May 30, 2014

Dr. Stella Swanson
Chair, Joint Review Panel
Deep Geologic Repository Project

**Deep Geologic Repository Project for Low and Intermediate Level Waste –
Submission of Responses to Information Requests in Package #12b**

**OPG Responses to Information Requests in IR Package #12b from
Joint Review Panel**

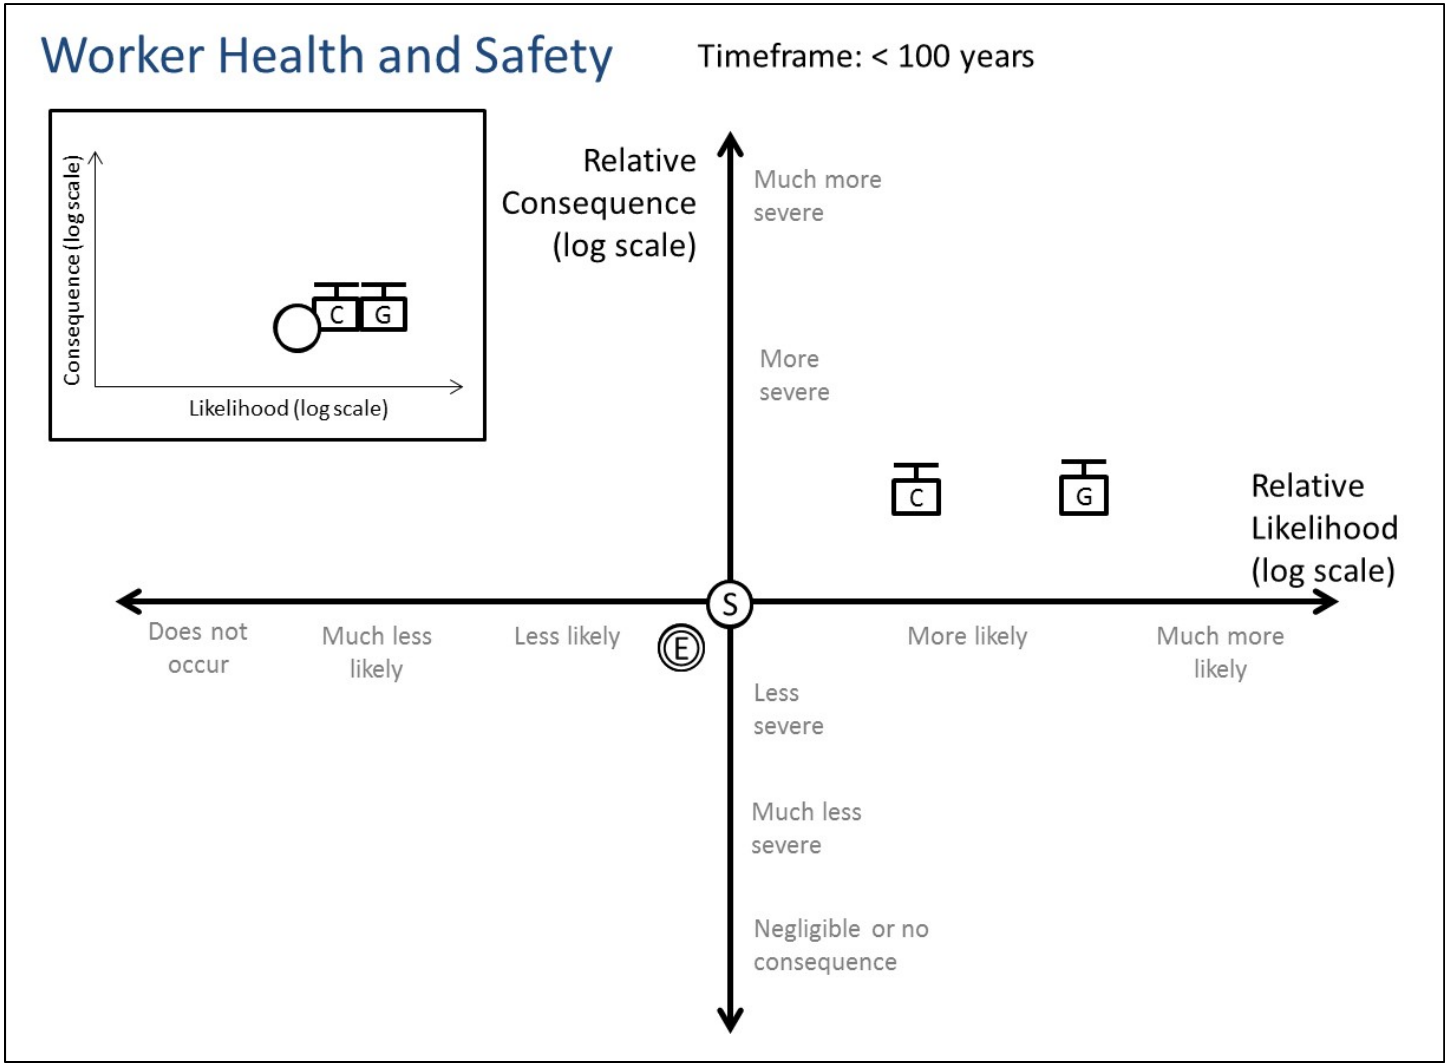
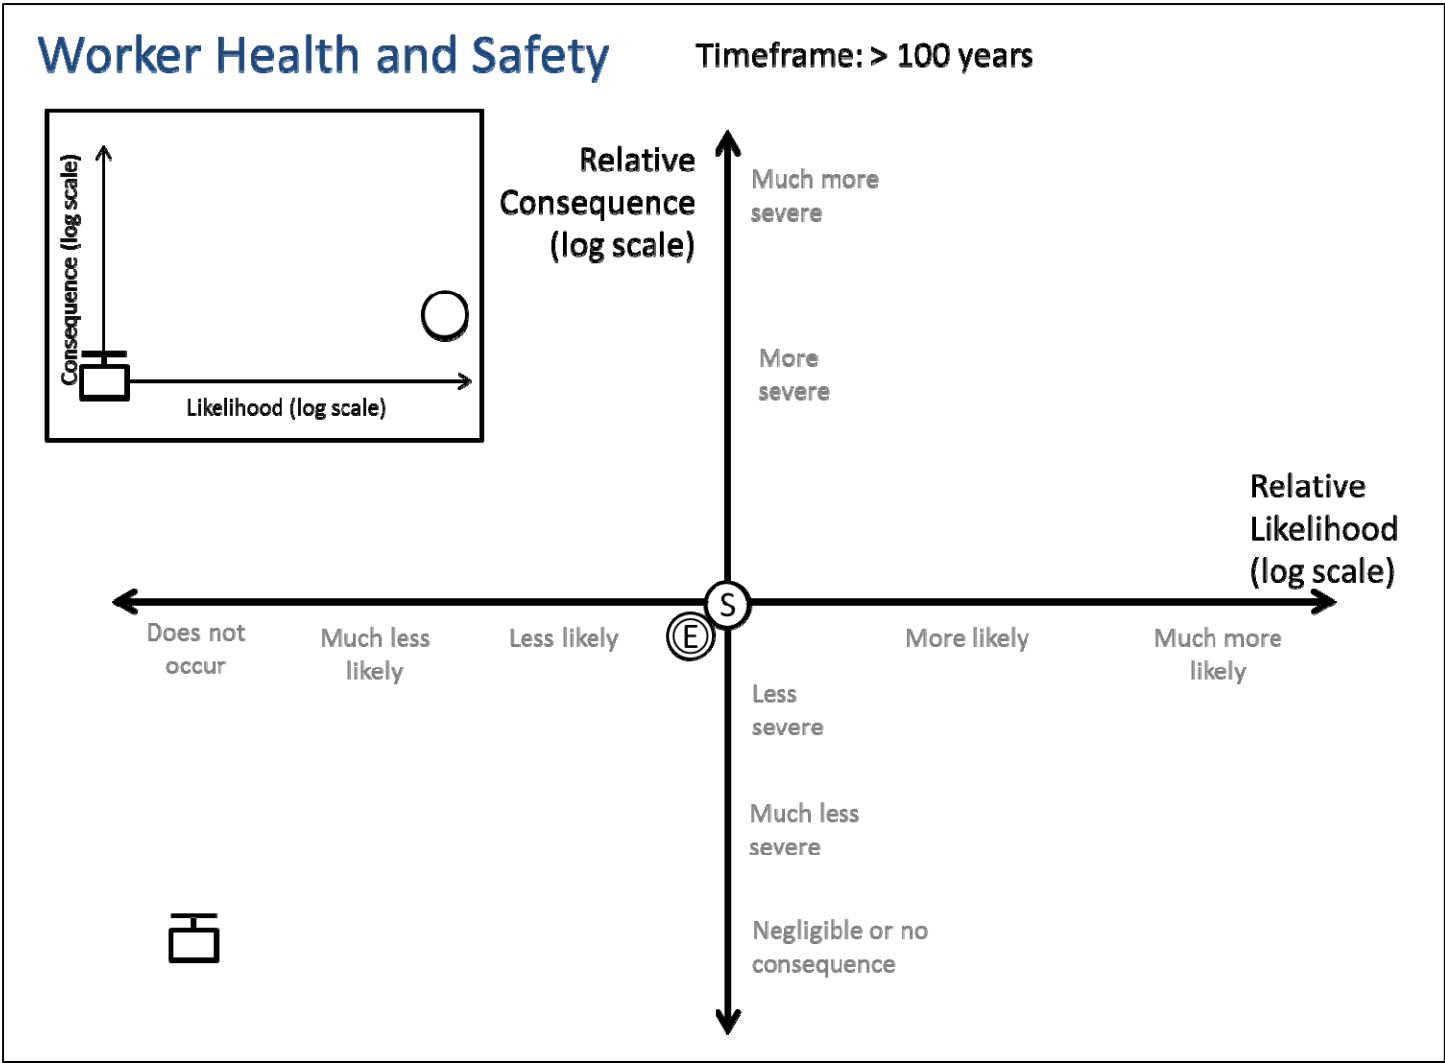
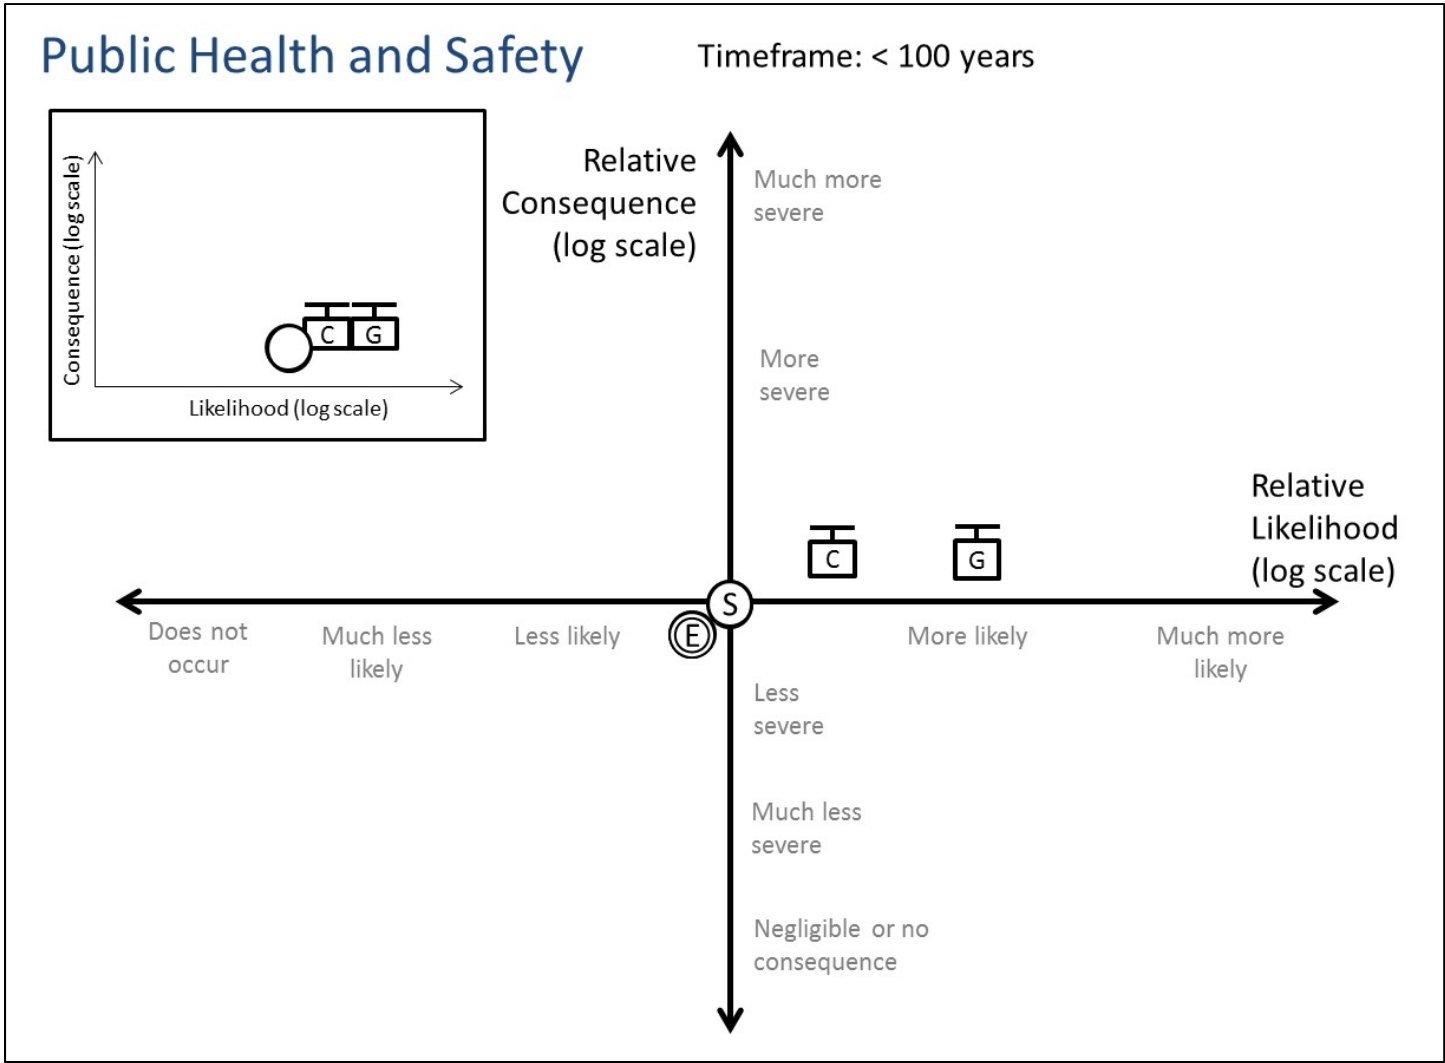
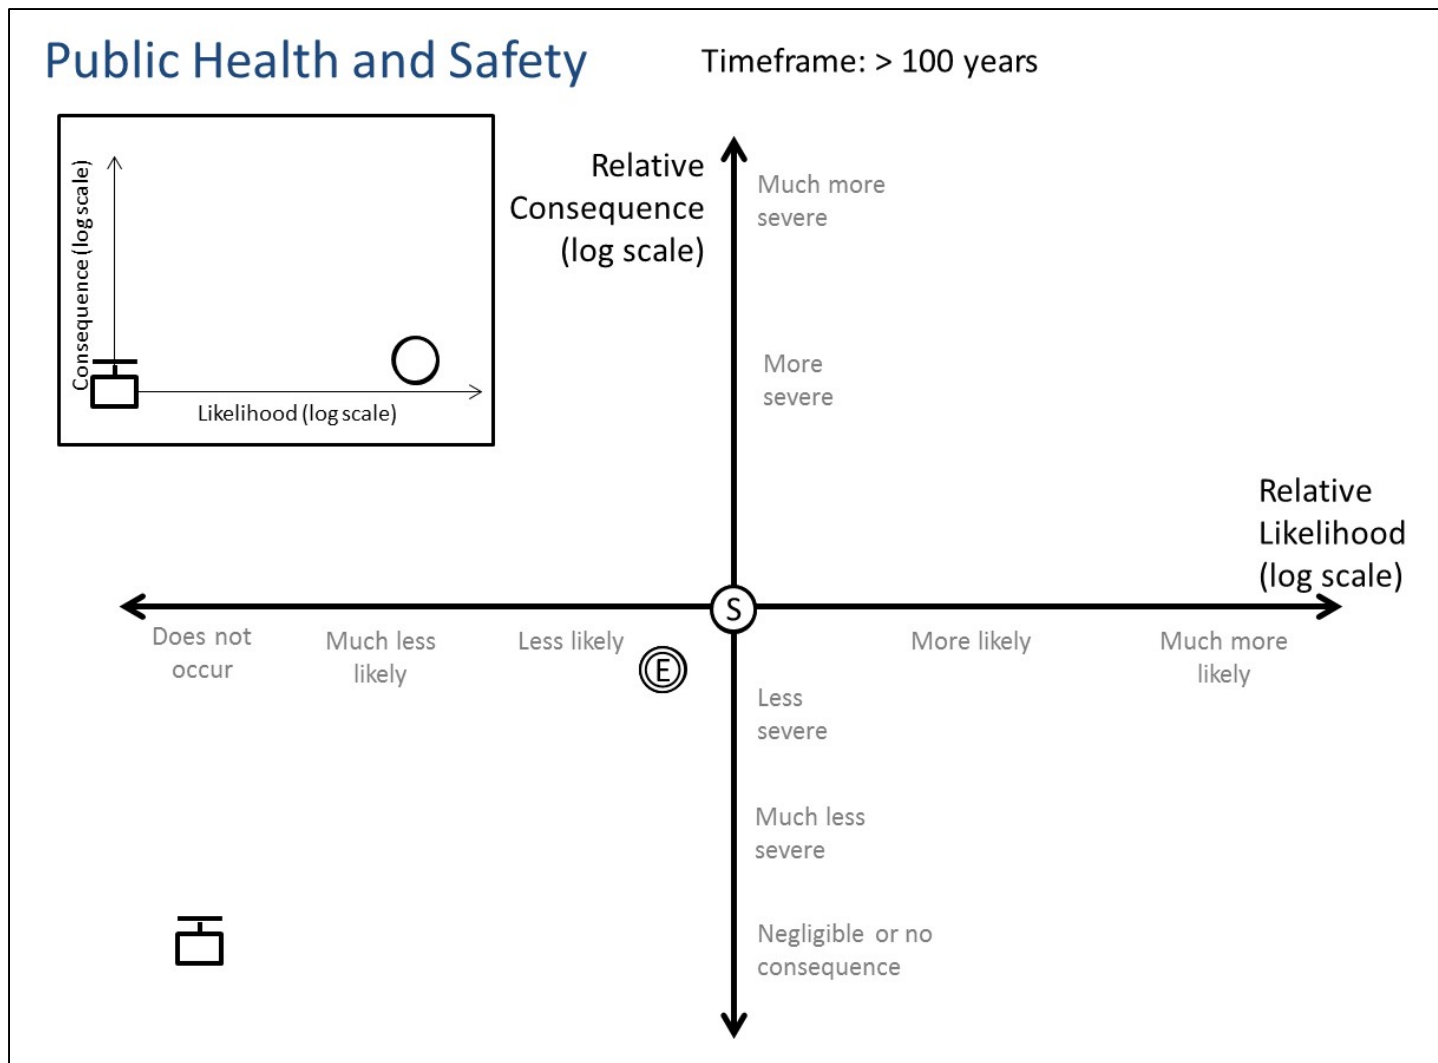
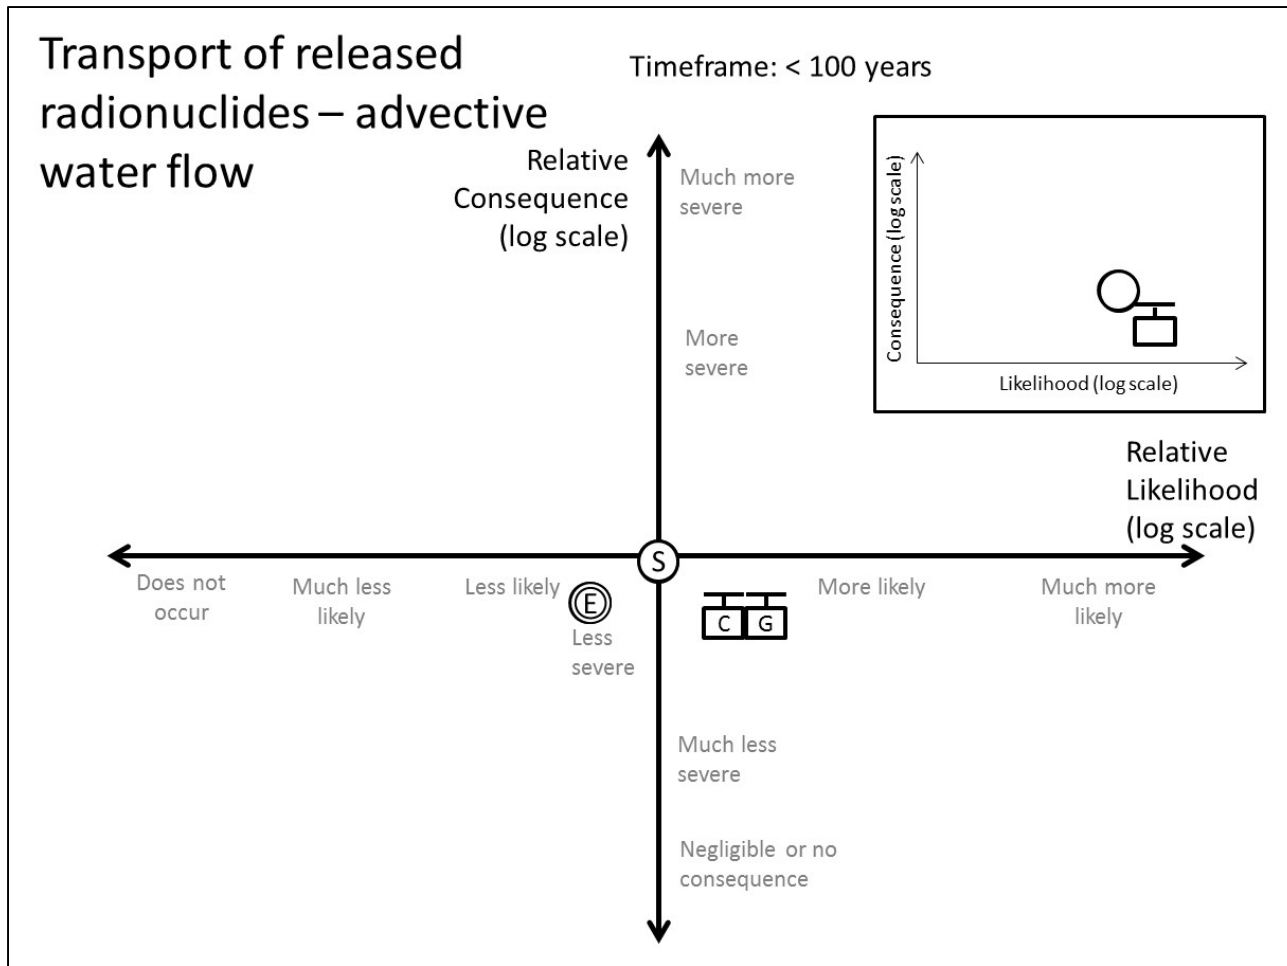
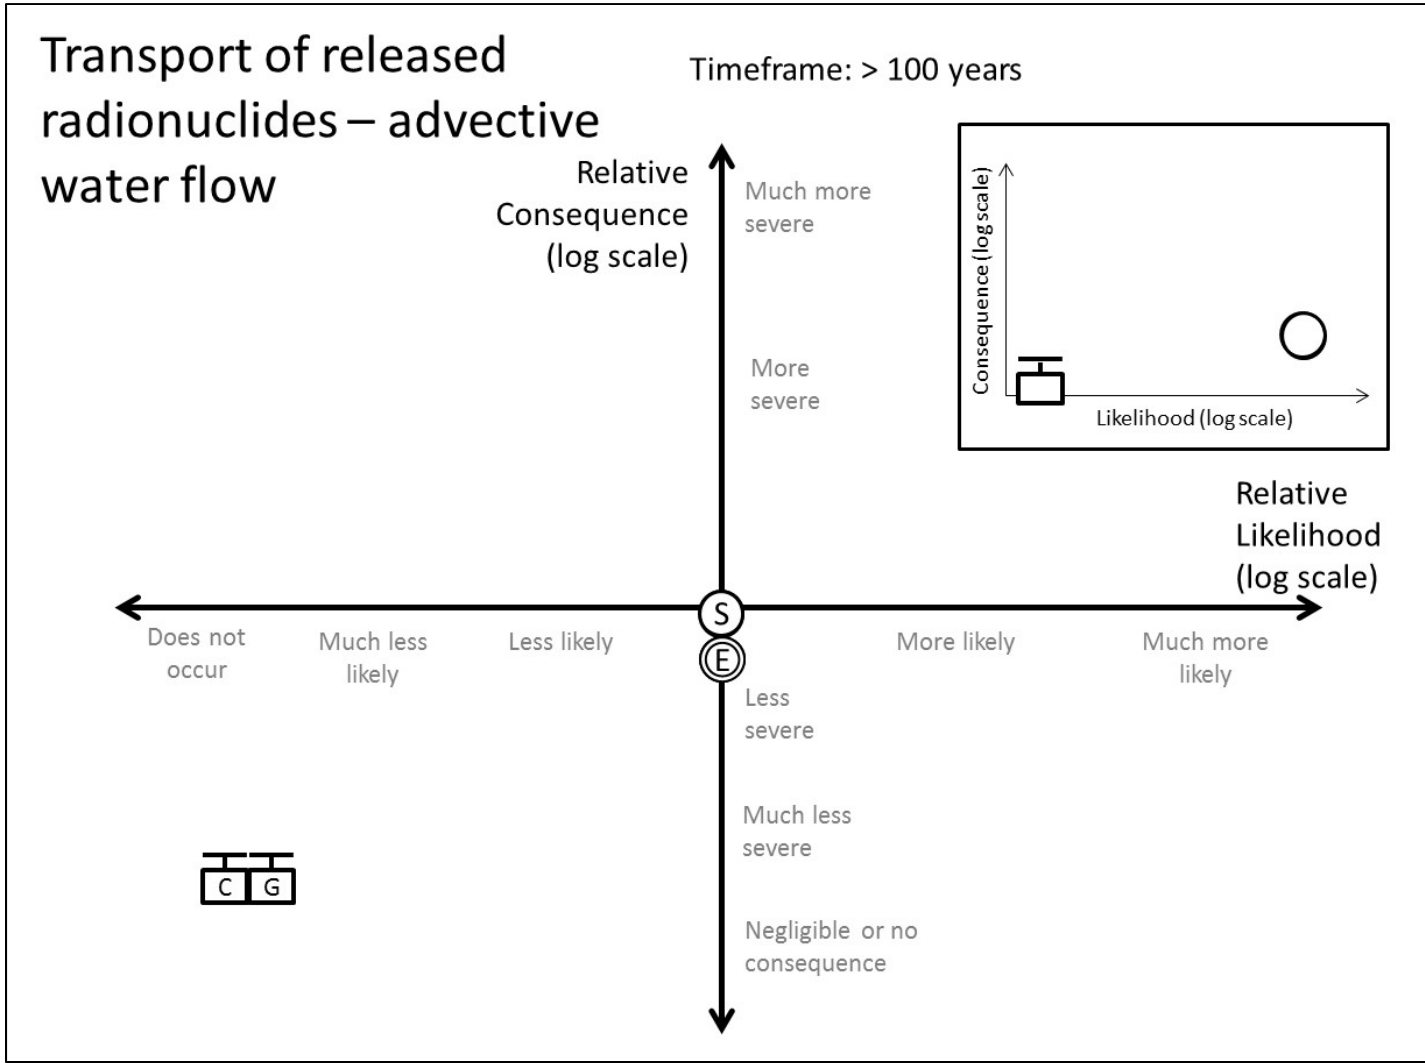
“a) Provide an indication of the log-log scale on the risk assessment plots, both Relative Risk and Absolute Risk, for the 12 key features (or pathways of harm) for comparison among the 4 alternatives for the near term (<100 years) and long term (>100 years) in order that the reader may distinguish negligible, low, moderate, high or very high risk assessments on these scales.

In response to part (a) of the request, we have provided the same relative risk and absolute risk plots with labelling to explicitly clarify that both the likelihood and consequence dimensions of the risk assessment plots have a logarithmic scale. These re-labeled plots are included as Appendix II of this report.
